July 9, 2026

SUBJECT: Overall Final EAO Water Information Request Response Summary

SUBJECT: **Tenas Project Water Quality EAO Information Request Response**

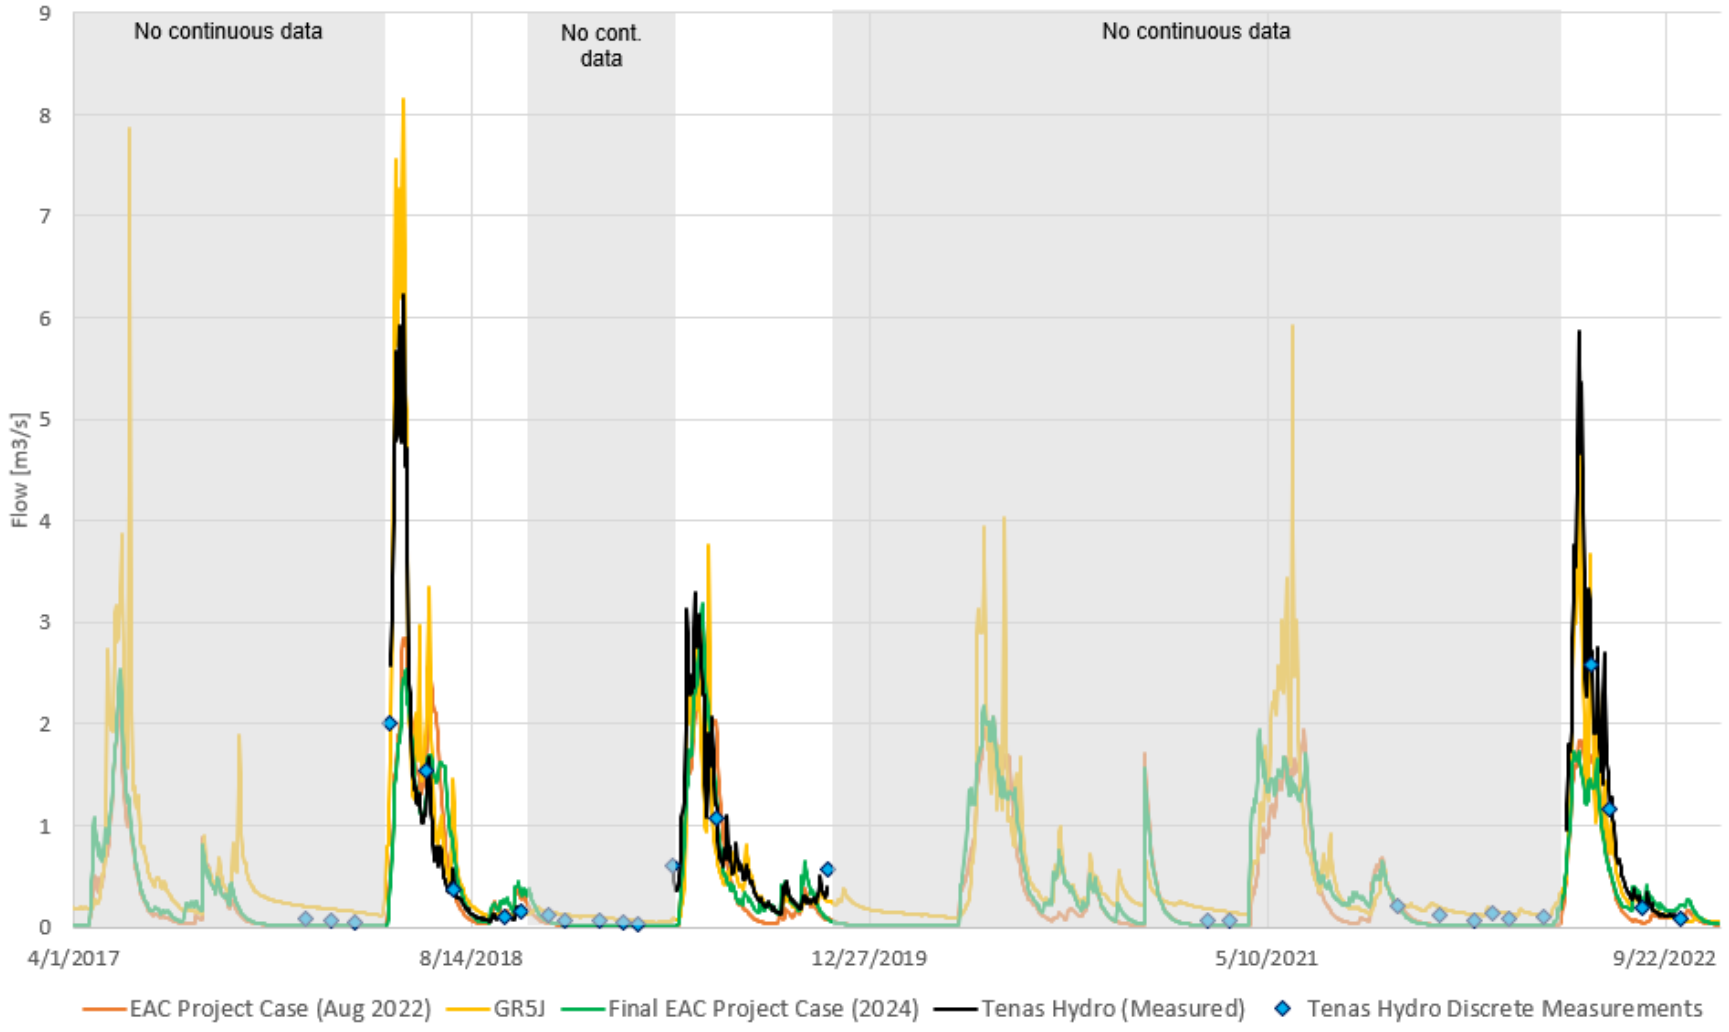
Given the minor difference in drainage area between Goathorn-Hydro and Goathorn (08EE008) (1% difference), I am surprised by the relatively large difference in unit discharge described by the selected linear regression (Figure 4-16). Is there a physical attribute that is suspected to drive this difference? Was any effort undertaken to understand the difference in rating curves between these stations, particularly at high flows? Is the unit runoff for the incremental area between these two stations reasonable in the QP's opinion? [Clarification]

Thank you for the response. I am struggling to understand why this linear regression (Figure 4-16) was selected by the QP as appropriate for this analysis, given the issues described in the response. Without being able to attribute the difference unit runoff/discharge from these similarly located stations to a physical attribute or rationalize an incremental unit runoff of roughly 80 l/s/km2 for the area between these stations, using a 0.8 or 0.85 ratio to scale the historic Goathorn WSC record to the site station represents flawed logic, in my opinion. In particular, the high flow regression is driven, in large part, by the extrapolated high flow section of the site rating curve, where the curve is not supported by stage-discharge measurements.
